# UNITED STATES PATENT AND TRADEMARK OFFICE

| APPLICATION NO. | FILING DATE | FIRST NAMED INVENTOR | ATTORNEY DOCKET NO. | CONFIRMATION NO. |
|-----------------|-------------|----------------------|---------------------|------------------|
| 10/630,039      | 07/30/2003  | Michael J> Berman    | 03-0800             | 9445             |

# Office Action Summary

Fig. 3

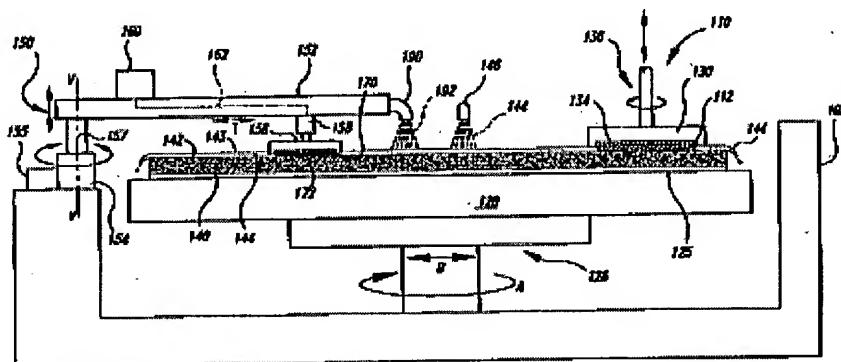
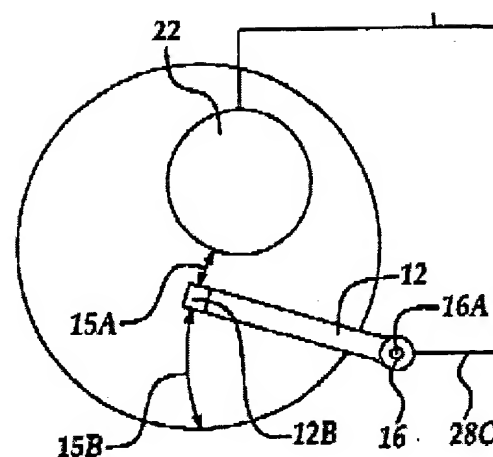
Southwick discloses all of the limitations of claims 1 and 11, i.e., a method of and an apparatus for wetting a semiconductor wafer, said method comprising using a wafer carrier (130) to hold the wafer to a polishing pad (140); dispensing a chemical (192) through at least one outlet (190) to the polishing pad; and moving the at least one outlet while dispensing the chemical.

Regarding claims 3-5, 7-10, 12-4 and 16-18, Southwick meets the limitations, e.g., arc and back and forth motion (rotational and up and down movement 04:38-54); rotating the carrier or the pad; movable arm (152) carrying the outlet and movable in arc or up and down motion.
